## ADDENDUM TO THE CONTRACT DOCUMENTS

ADDENDUM NO. 002
	Project: Solano Community College District <b>Building 1400 Lighting Upgrade</b> Project Number: 26-000
	Date: April 13, 2026

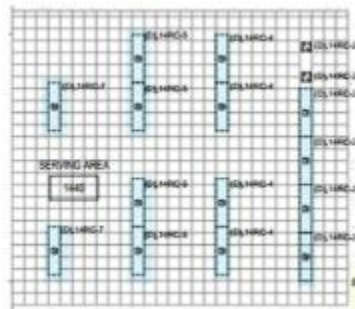
**Question:** On Drawing 3.2, Note (1) states:

“Typical, remove from (E) 120V circuit and connect to nearest 277V circuit indicated for new lights. Reuse existing conduits and conductors where possible, provide new where required.”

However, the existing conduit routing, junction box locations, and existing circuit pathways are not shown on the contract drawings.

Please clarify how bidder is to identify:

- Which existing conduits and conductors are to be reused,
- The routing for new conduits and conductors, and
- The location of the nearest 277V circuit indicated for connection.

**Response:** Existing conduits and conductors shall be reused where possible. Where new is required, contractor shall field verify and provide. The 277V circuit is indicated on the drawings by the circuit label next to the fixture.

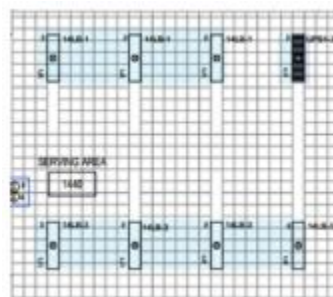
**Question:** In the southeast serving area shown on Drawings E2.4 and 3.4, new light fixtures are indicated, and some existing fixtures are shown to be relocated; however, no wiring routes are shown on the drawings.

Please clarify whether branch circuit wiring for these fixtures is existing and intended to be reused, or if the contractor is required to provide and install new wiring as needed. If new wiring is required, please confirm whether routing, circuiting, and quantities are to be contractor-designed and estimated as part of the bid.

**Response:** For this location it is intended for contractor to provide new conduits and conductors connected to the circuit indicated on the plans.
